delabs Technologies
Electronic Product and Process Design

Date: Friday, August 29, 2003 Sheet 1 of 1 Rev 00

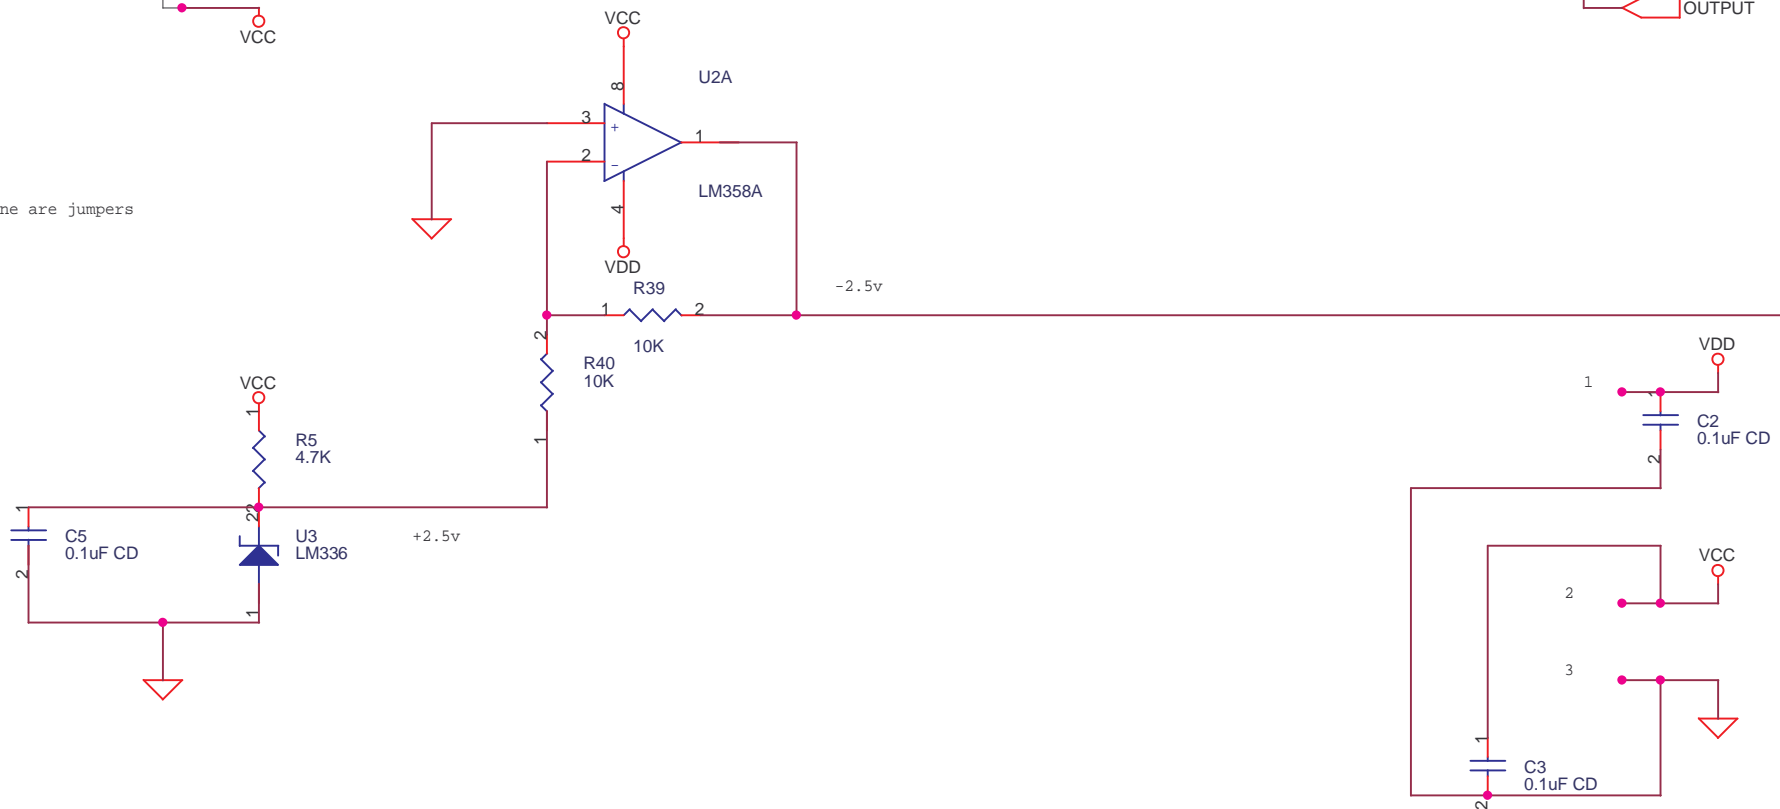
REDUCE R8 IF REQUIRED TO REDUCE RTC FURTHER

REPLACE R22* BY 5K TRIMPOT THIS IS LIN POT P2

dashed line are jumpers

- THE CIRCUIT HAS BEEN ADAPTED TO THE COMPONENTS USED BY YOU
- OP07 RF WAS 200K OP07 RI WAS 330E + 1K TRIMPOT
- OP07 OFFSET WAS 2X10K + 1K PRESET USE 10K PRESET FOR COARSE ACTION
- USE A 10 K OFFSET POT FOR OP07 IF RT SETTING POT P1 GOES OUT OF RANGE
- IK PRESET ABOVE CENTRE GOES TO VDD IE OFFSET POT
